To: Kristopher Byrd, Well Construction and Compliance Section Manager
From: Travis Kelly, Well Construction Program Coordinator
Subject: Review of Water Right Application G-18901
Date: April 16, 2020

Application # G- 18901

TO: Water Rights Section Date April 14, 2020
 FROM: Groundwater Section Aurora C Bouchier
 Reviewer's Name
 SUBJECT: Application G- 18901 Supersedes review of NA
 Date of Review(s)

**STATE OF OREGON
WELL LOCATION MAP**

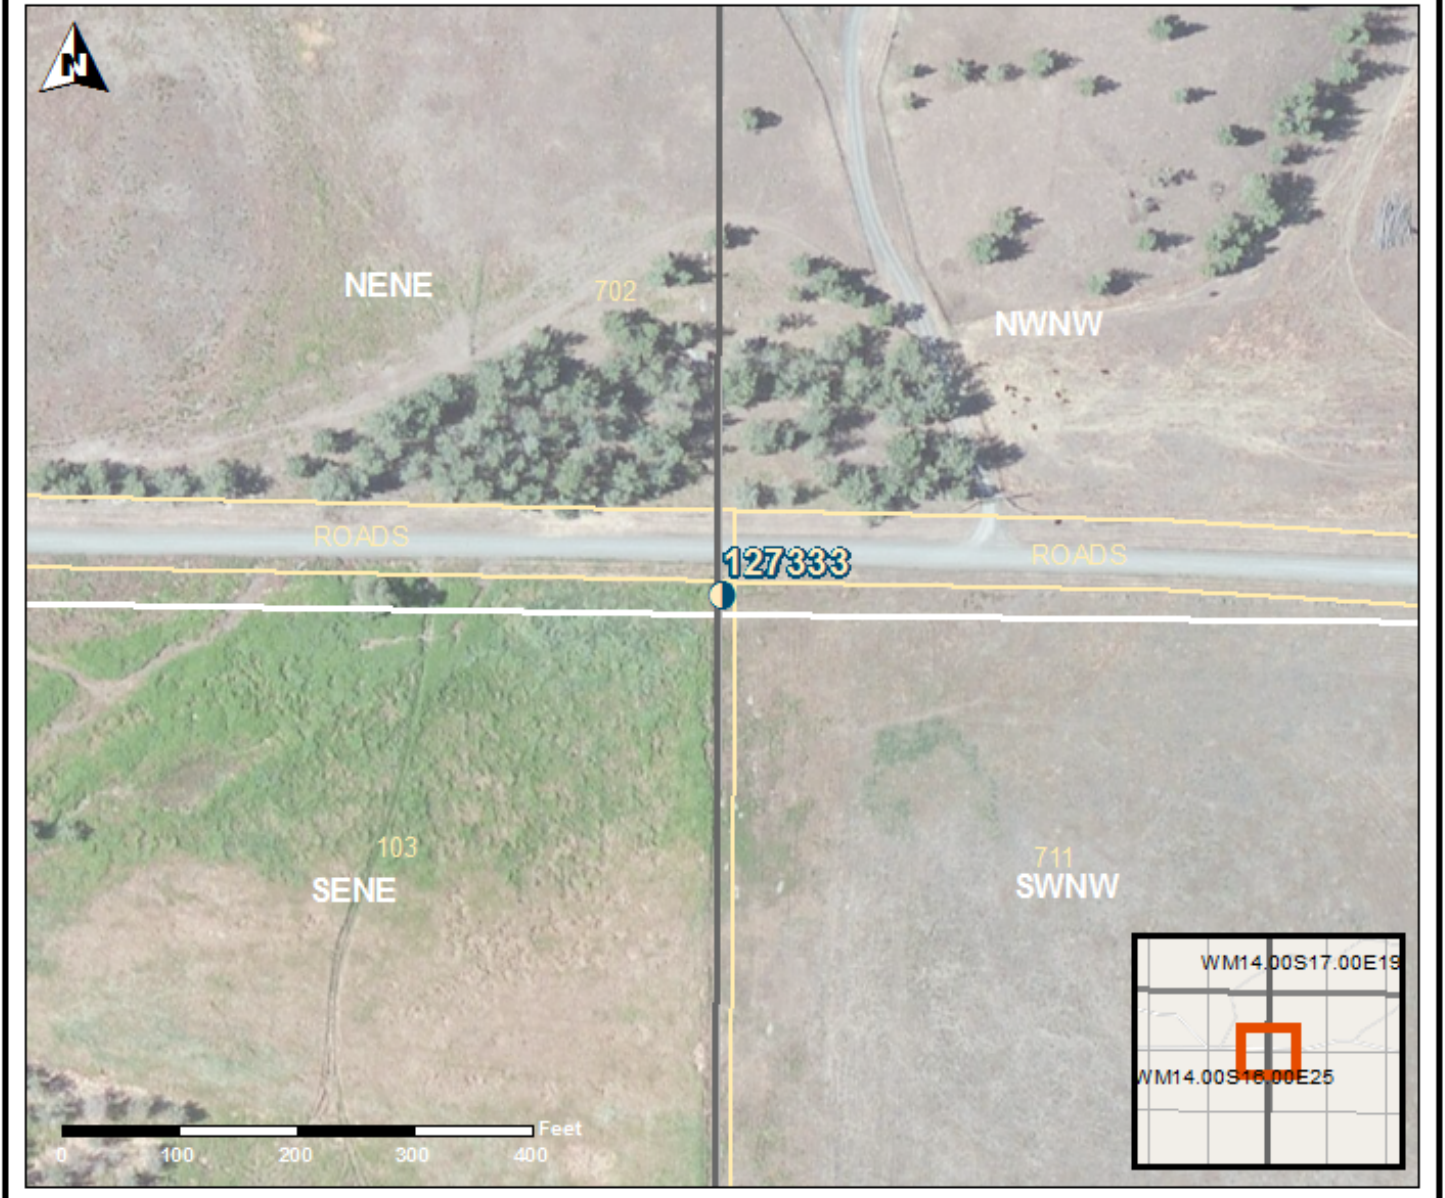
Applicant's Well #1 (CROO 54530): Based on a review of the Well Report, Applicant's Well #1 seems to protect the groundwater resource.

The construction of Applicant's Well #1 may not satisfy hydraulic connection issues.
